# Tampa Electric Company (TECO)
# Coal Yard Assessment
## Stantec Job No. 198800347

September 2010
Revision 2

Stantec has been retained by Tampa Electric Company to provide a review of the coal field equipment at the Big Bend facility. The review scope boundaries are from the dock through conveyors L1 and L2 that bring the coal to the tripper deck in the power house.

PICTURE TTWR-T3-AC

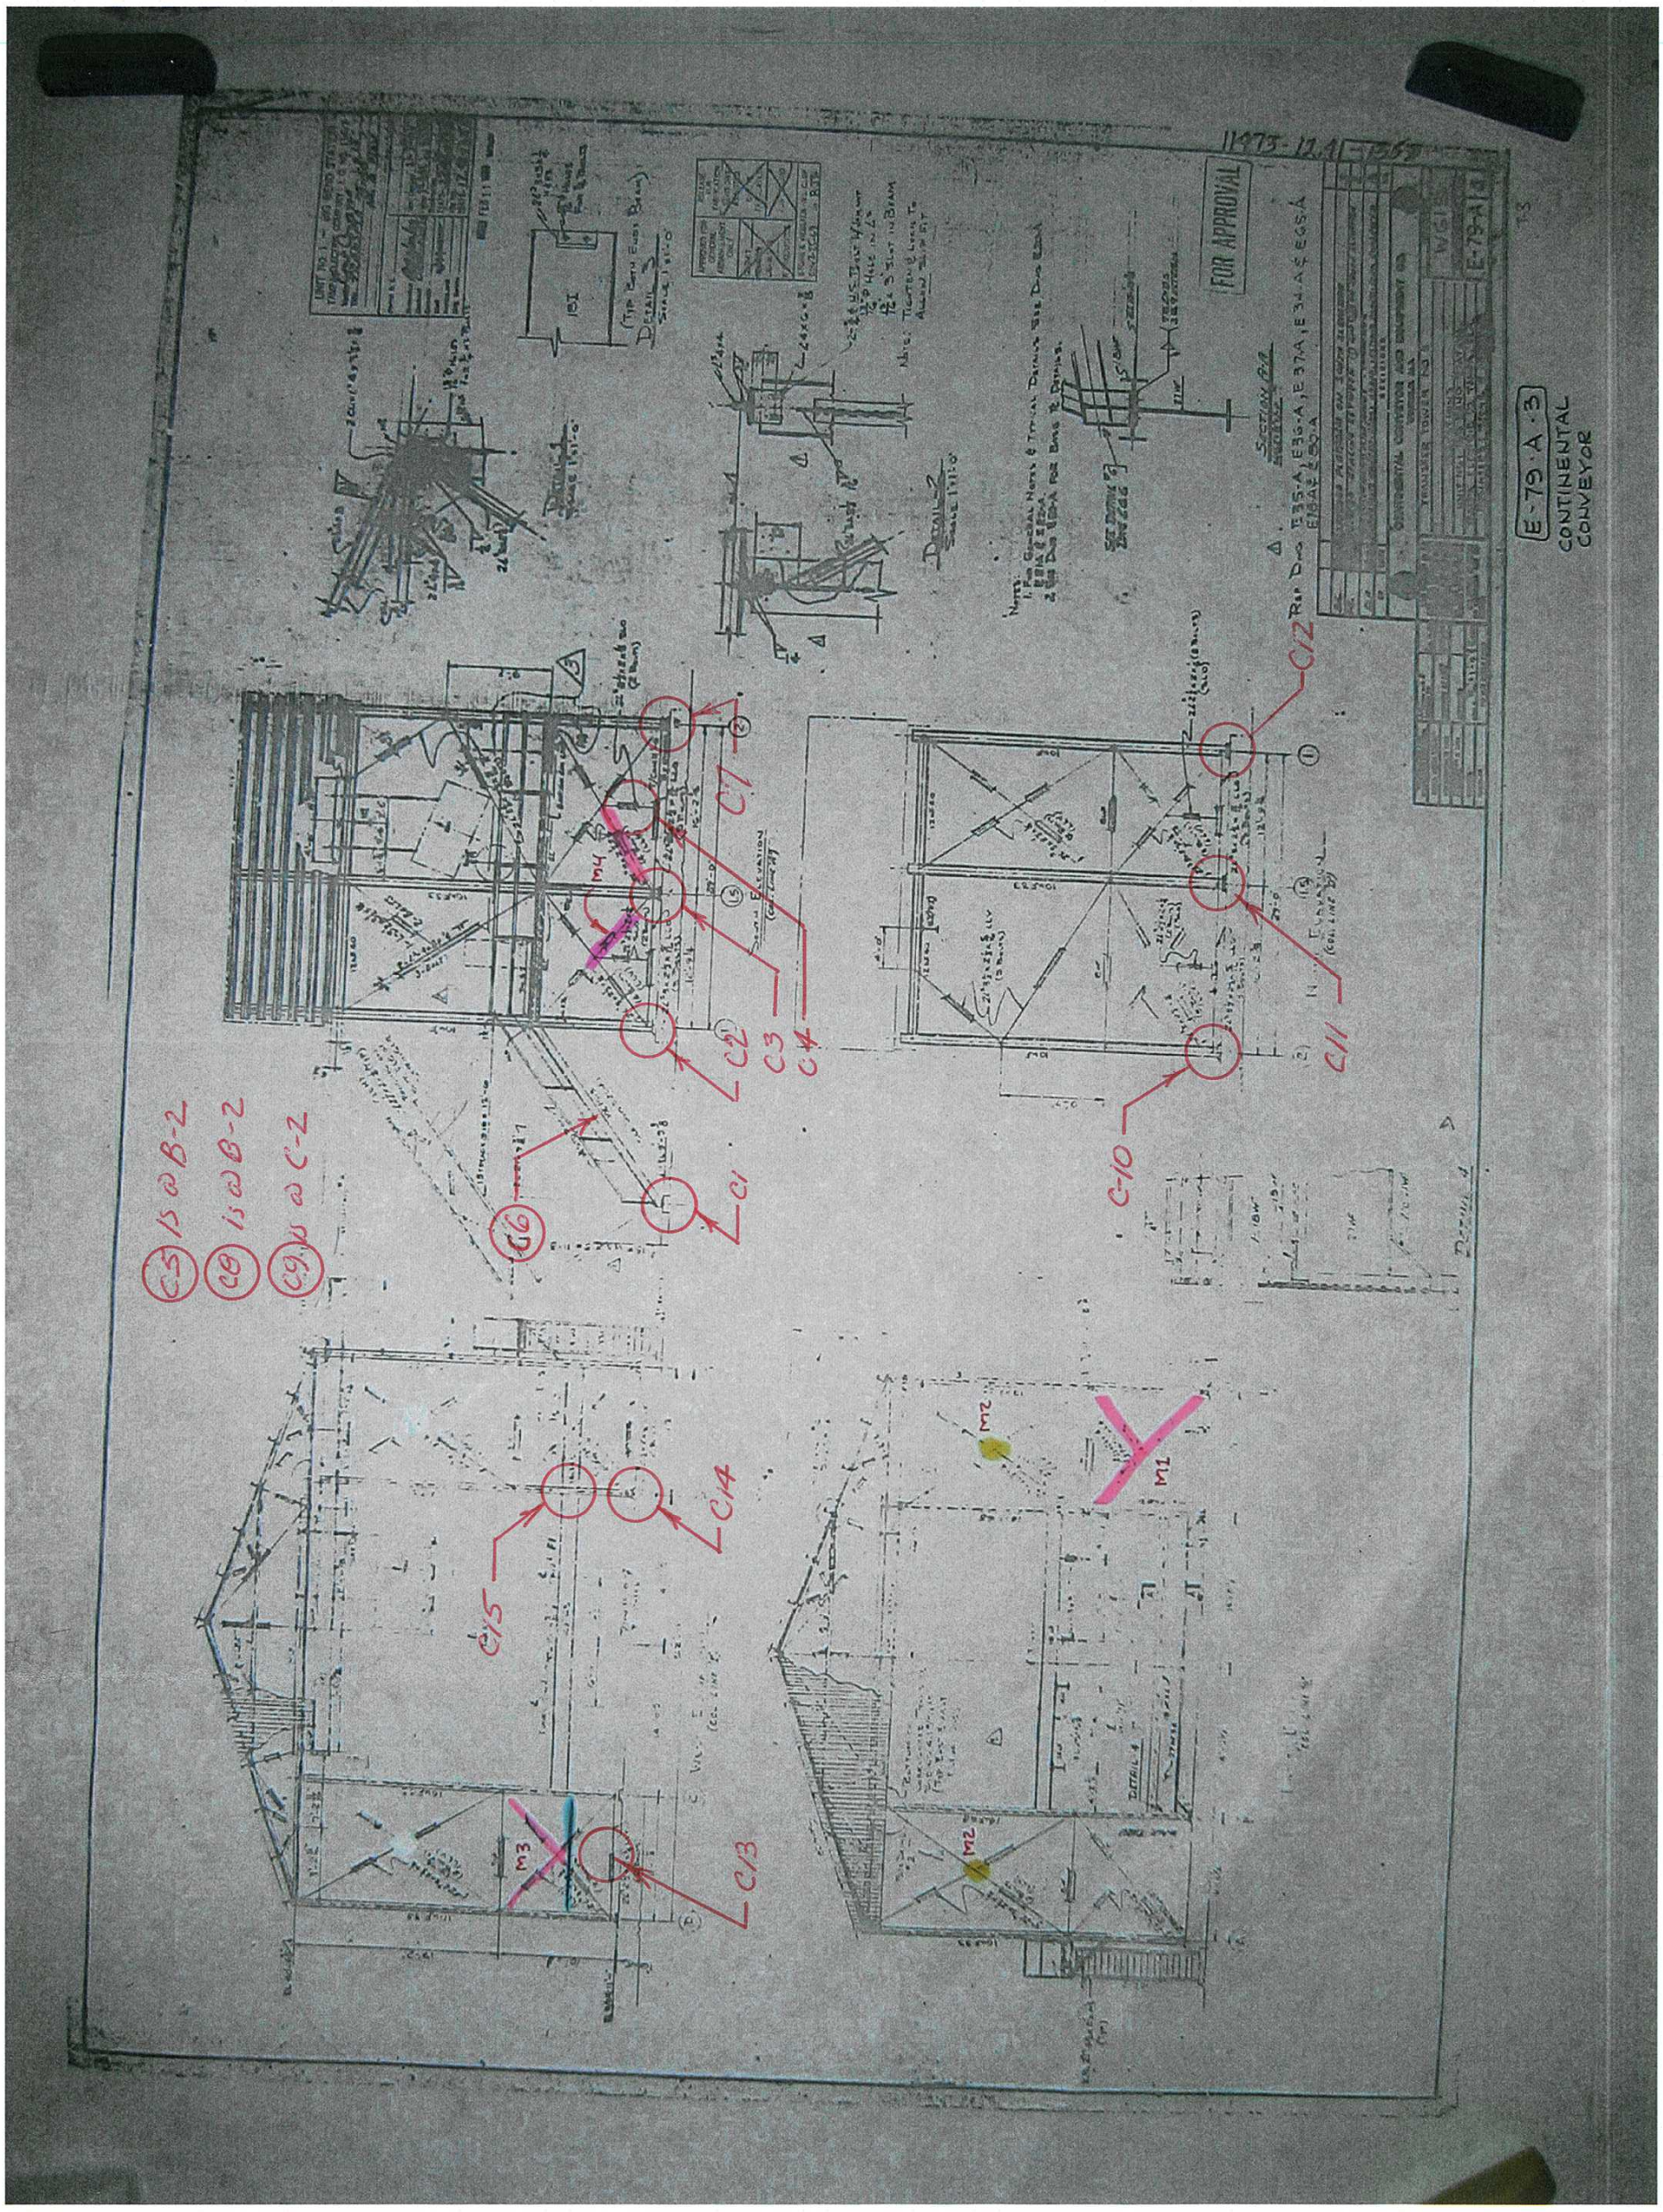
Pictures TTWR-T3-AA, TTWR-T3-AB and TTWR-T3-AC show the general condition of the floor framing systems. Coal accumulation on the grating and the presence of moisture has lead to corrosion of the grating and the support steel in many areas. The grating surfaces should be kept free of coal and the corroded areas cleaned and painted to minimize further corrosion. Should cleaning of the members back to solid metal expose significant corrosion, repairs or replacement will be required.

PICTURE TTWR-T3-AD

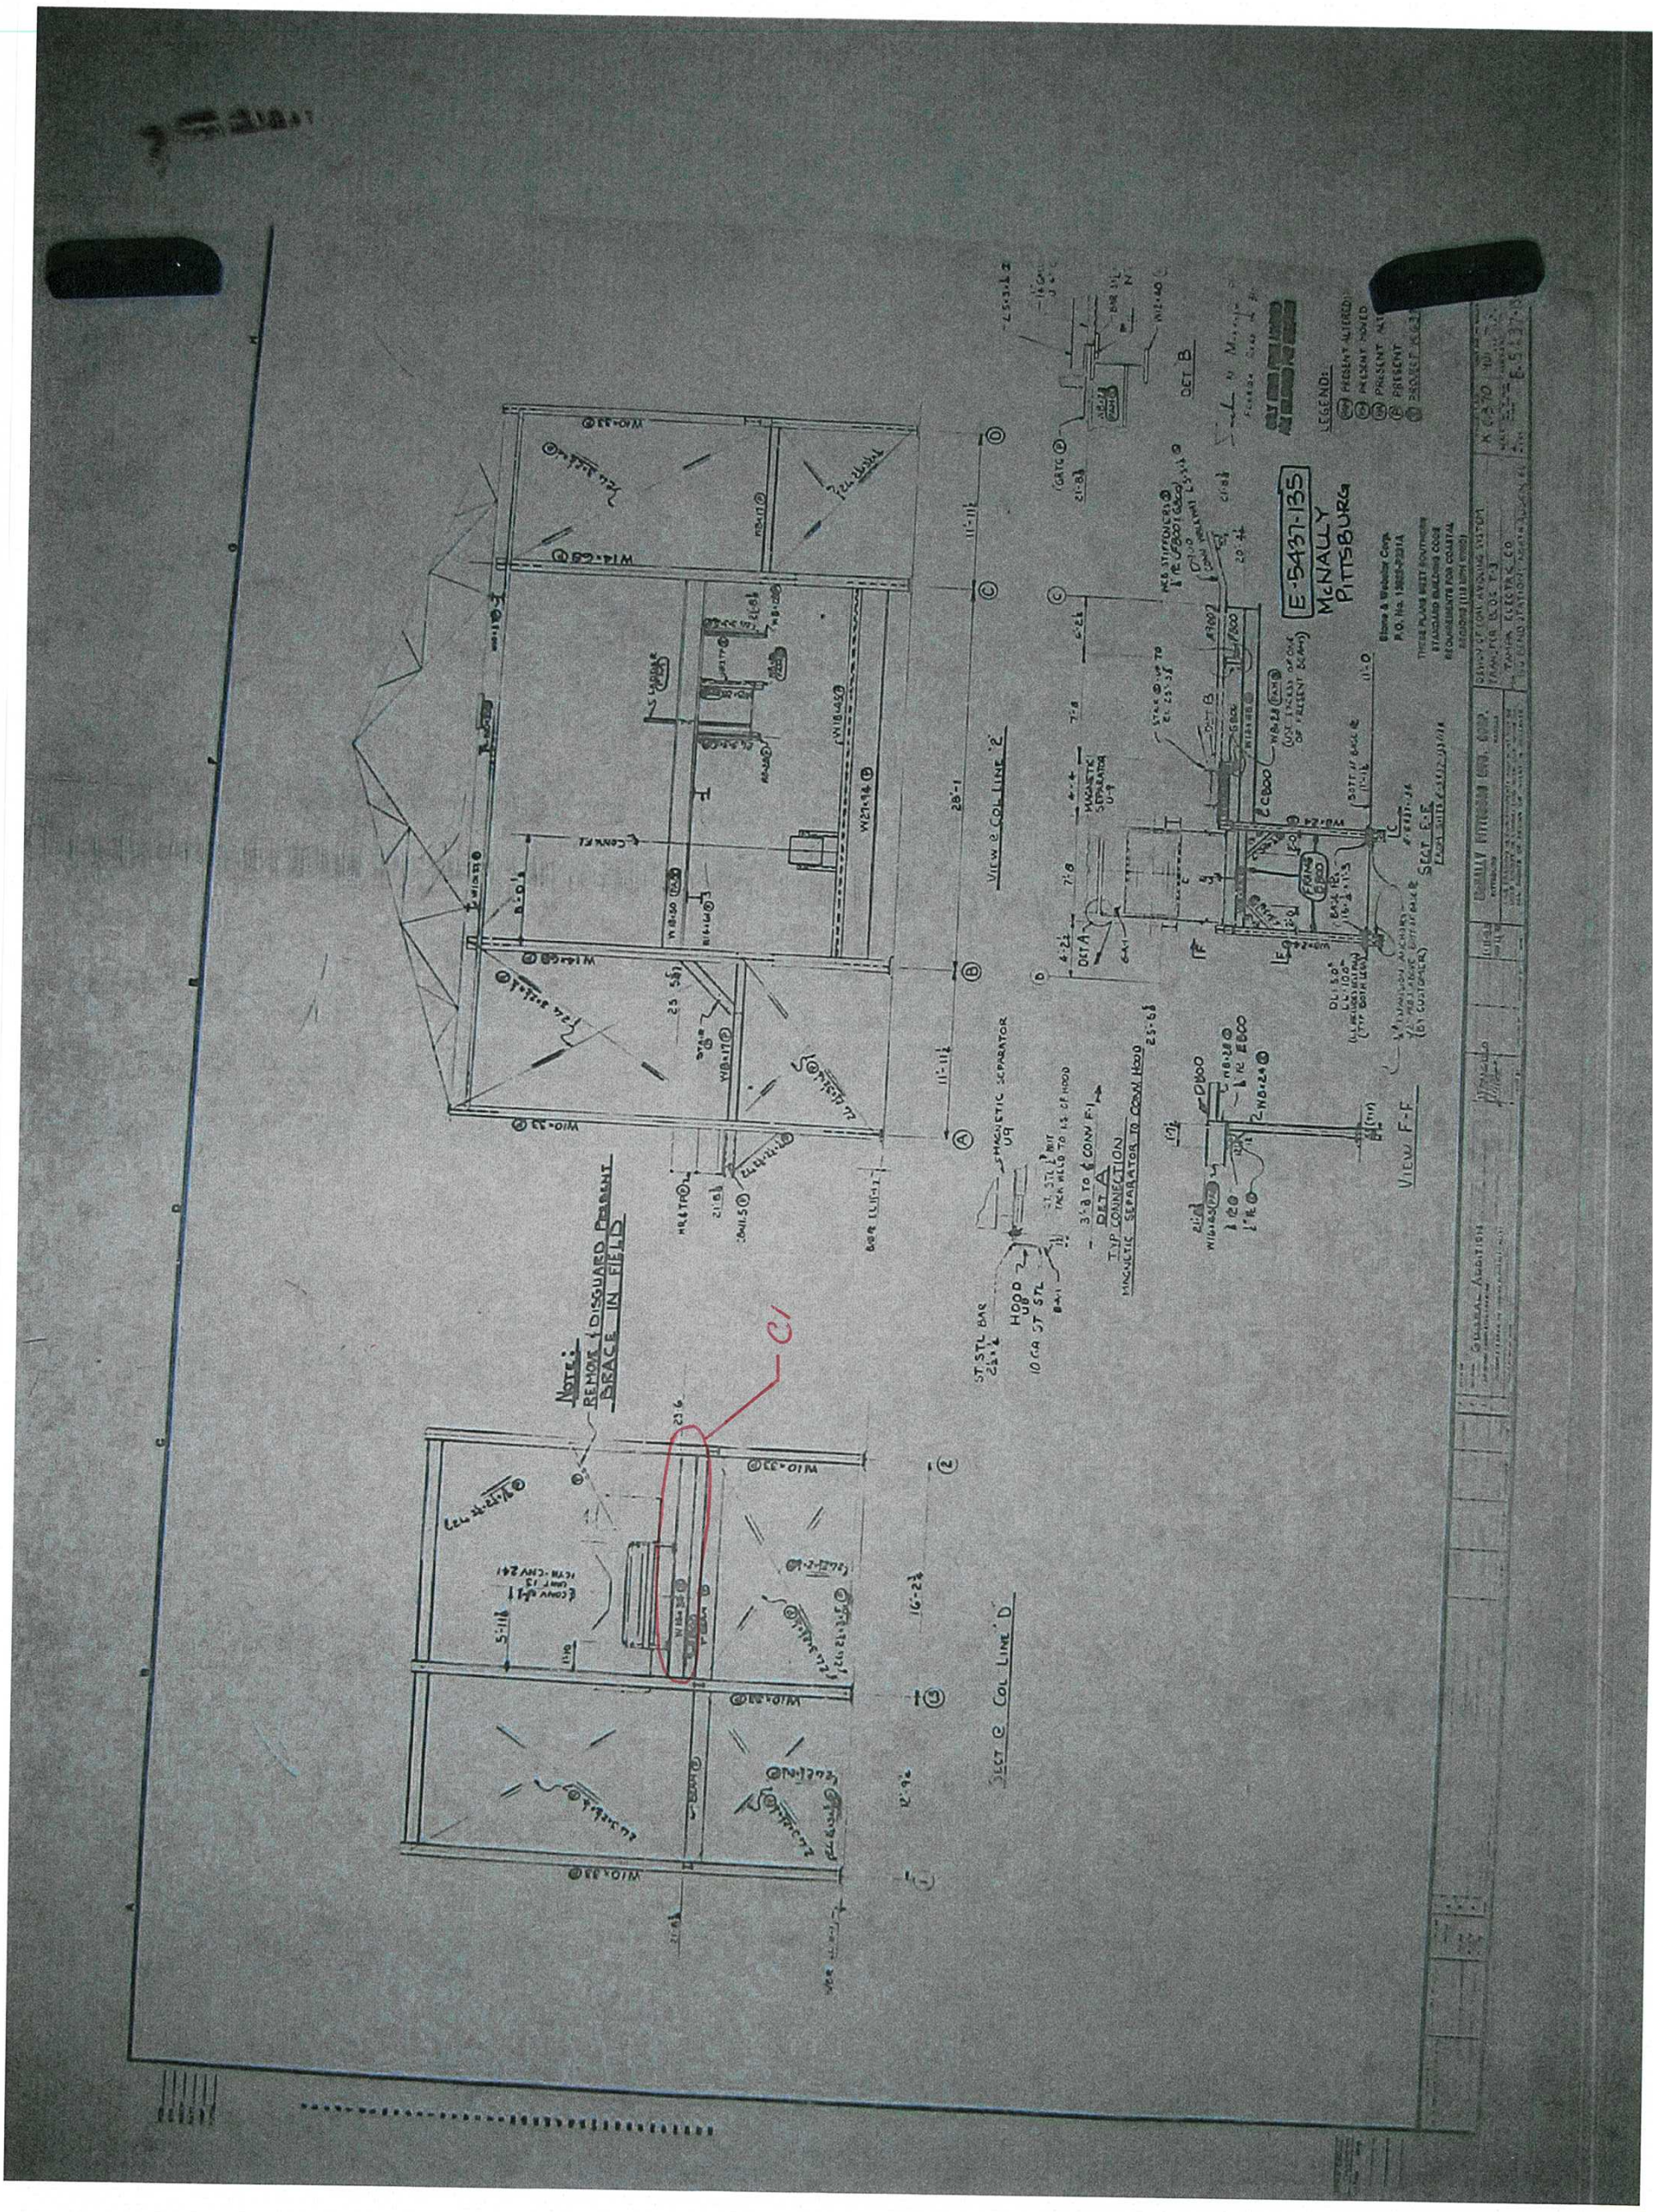
C-1 Framing supporting Conveyor J1 has severe corrosion as seen in picture TTWR-T3-AD. Framing needs cleaning and painting/repair as required.
